Agenda Report San Clemente City Council Meeting

Meeting Date: March 19, 2013

CONSTRUCTION OF PERMANENT WEDDING SITE AT THE MUNICIPAL GOLF COURSE

Figure 1. Proposed Wedding Venue at the Chip and Putt Green

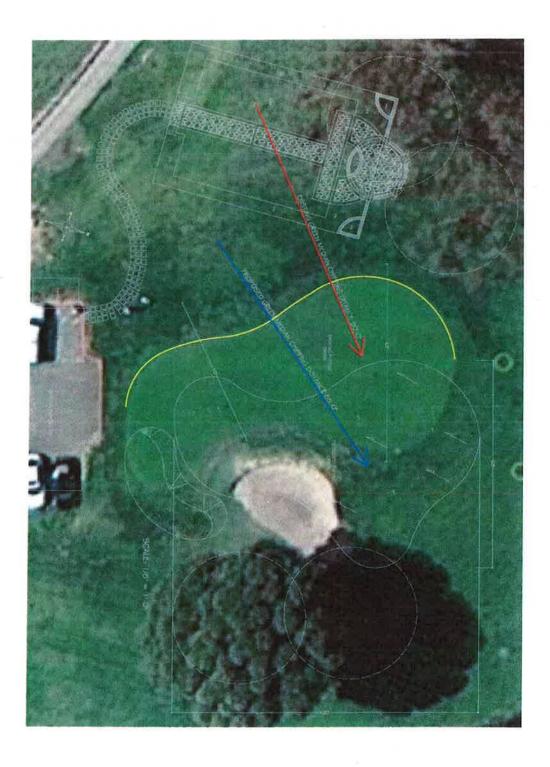
At its regular March 7, 2013 meeting, the Golf Course Committee reviewed the updated proposal for a wedding site in the chip and putt area of the course submitted by Z Golf. After a lengthy discussion that included the consideration of an alternate plan submitted by teaching pro Rocky Rafkin, the Golf Course Committee voted 6-0 (CM Gooch absent) to recommend that City Council approve the wedding site plans with the following recommended modifications:

- 1. Shift the altar location slightly to the west so that it is not located on top of the irrigation mainline and to open up the pitching alley up to the targets on the slope.
- 2. Re-configure the meandering pathway to the site so that it takes up less chipping area.
- 3. Add and show on plans the larger screening plantings that will be necessary to block unwanted views and give privacy to the area.
- 4. Remove the rectangular border of the venue and replace with a softer edge more appropriate for park like setting. The Golf Course Committee requested also that the eastern edge be opened somewhat, to provide a more open feeling, allow flexibility in seating, allow easier access in and out, and to provide more chipping area when not in use as for wedding ceremonies.

Representatives of Z Golf present at the meeting indicated that the proposed changes were acceptable, thanked the Golf Committee for their approval, and reiterated their desire to move forward quickly on the project. To expedite construction, Z Golf is suggesting phased construction, with the dais and path to be constructed first at a location sited by the Golf Manager to ensure no conflict with the irrigation mainline and at a location that is in

keeping with the requested modifications of the Golf Course Committee (recommended modifications 1 and 2). Recommended modifications 3 and 4 involve the placement of plants as a landscaping buffer and would be phased in afterward with a plan approved by the Golf Manager and Golf Course Committee Chair to streamline the process.
